V2500-A1 SERIES PROPULSION SYSTEM SERVICE BULLETIN

This document transmits Revision 3 to Service Bulletin EV2500-72-0449

V2500-ENG-72-0449

ENGINE – HP COMPRESSOR RING CASES – INTRODUCTION OF HPC STAGE 4 ROTOR PATH TRENCH
WITH INCREASED TIP CLEARANCE

Assembly Instructions
Figure 1

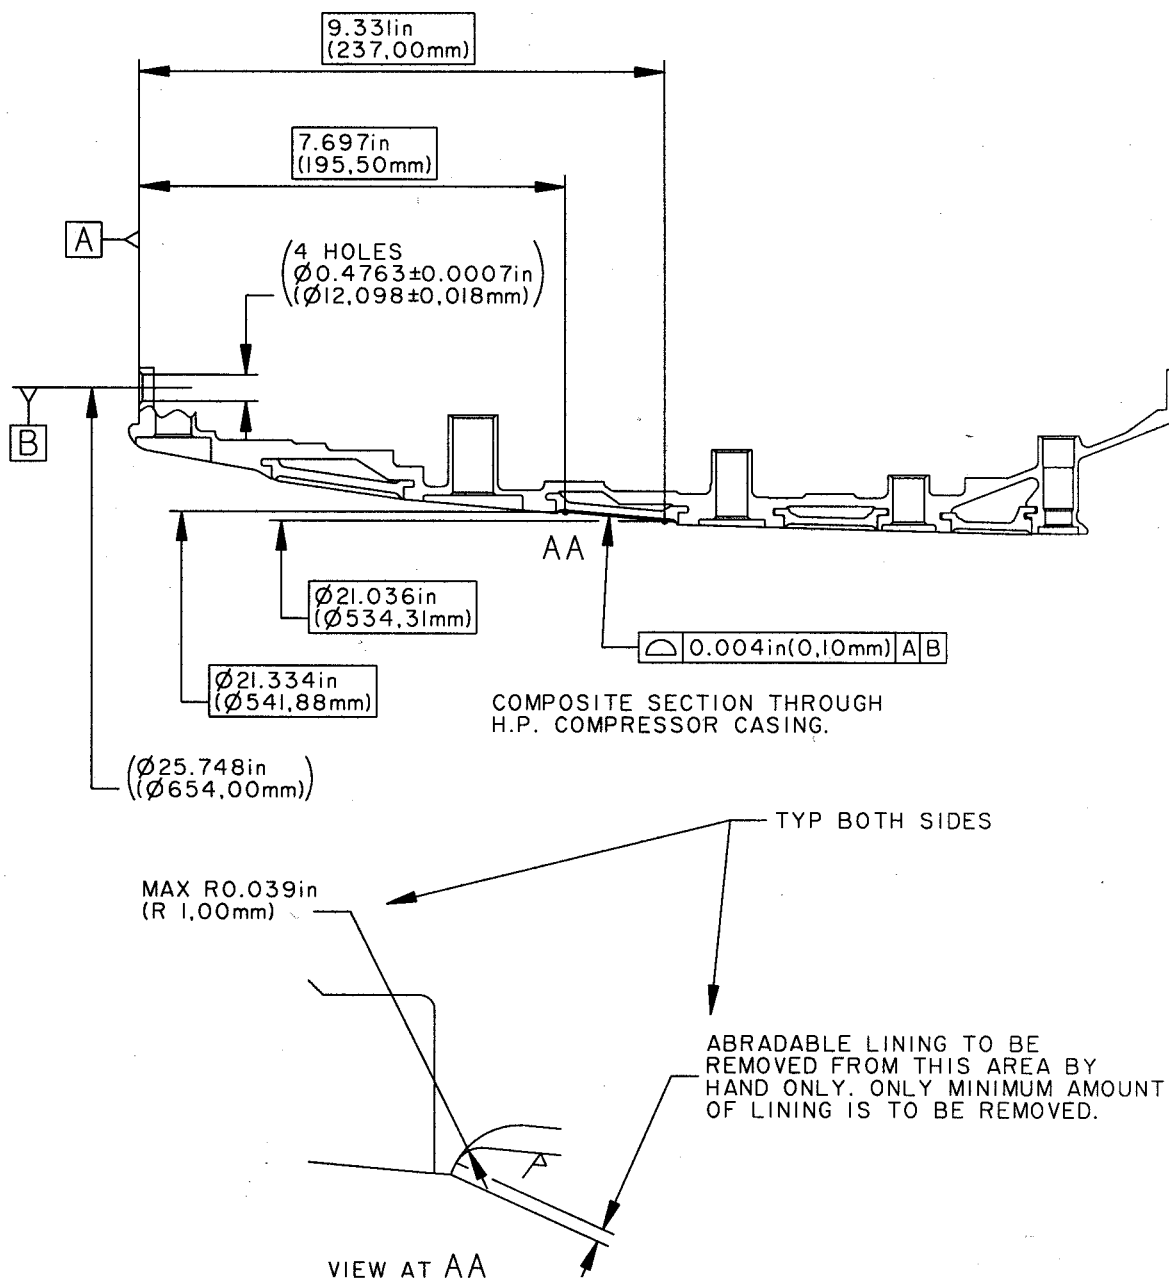
A trench has been introduced to the HPC Stage 4 Rotor path across the full axial width of the liner to a nominal depth of 0.040in. (1,016 mm.).

NOTE: For Subtask 72-41-30-324-052-A00 Para 13.E, refer to Figure 1 of this Service Bulletin for dimensional profile of Stage 4 Rotor Path.

FOR ENGINES NOT INCORPORATING SB 72-0027

MACHINE WHERE MARKED ✓
MACHINED SURFACE FINISH TO BE 126 MICROINCHES (3.2 MICROMETRES).
THE GEOMETRIC SYMBOLS ARE AS GIVEN IN THE ISO MANUAL (R1101).

Assembly Instructions
Figure 2

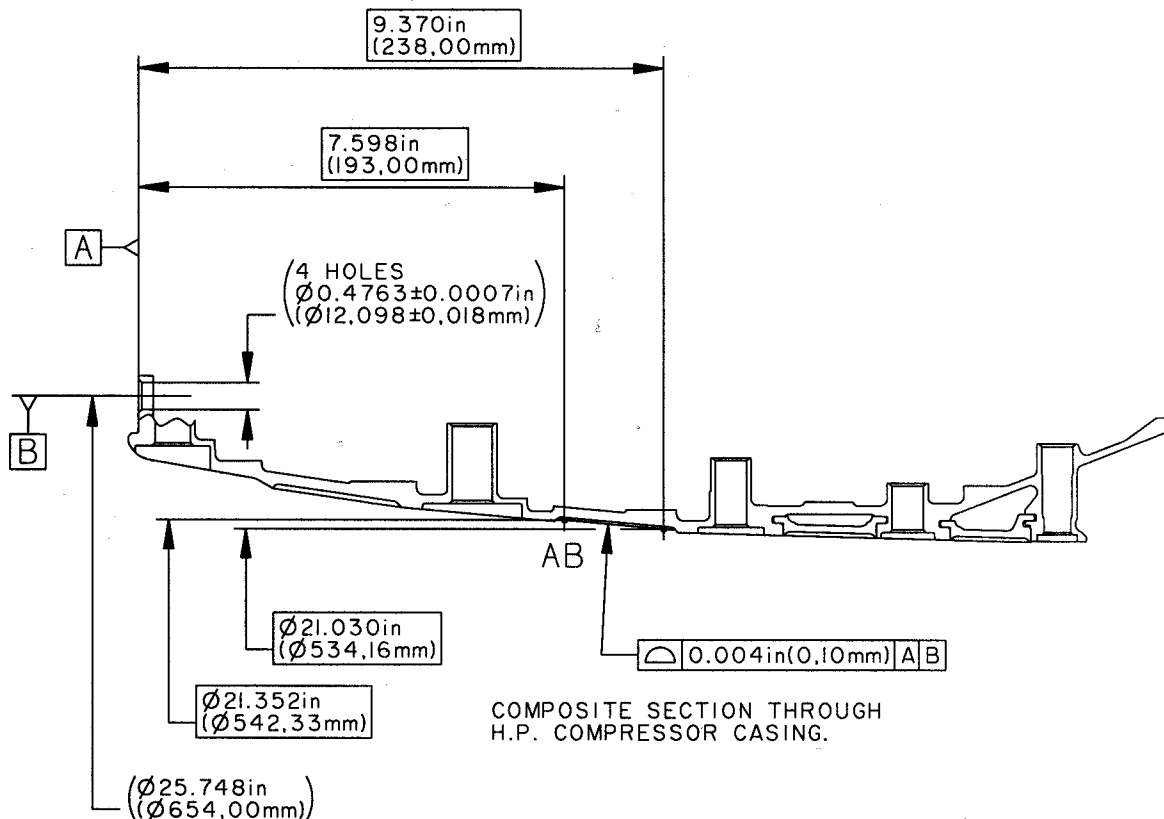
For Subtask 72-41-30-324-052-B00 Para 14.E, refer to Figure 2 of this Service Bulletin for dimensional profile of Stage 4 Rotor Path.

ABRADABLE LINING TO BE
REMOVED FROM THIS AREA BY
HAND ONLY. ONLY MINIMUM AMOUNT
OF LINING IS TO BE REMOVED.

FOR ENGINES INCORPORATING SB 72-0027

MACHINE WHERE MARKED ✓
MACHINED SURFACE FINISH TO BE 126 MICROINCHES(3,2 MICROMETRES).
THE GEOMETRIC SYMBOLS ARE AS GIVEN IN THE ISO MANUAL (R1101).
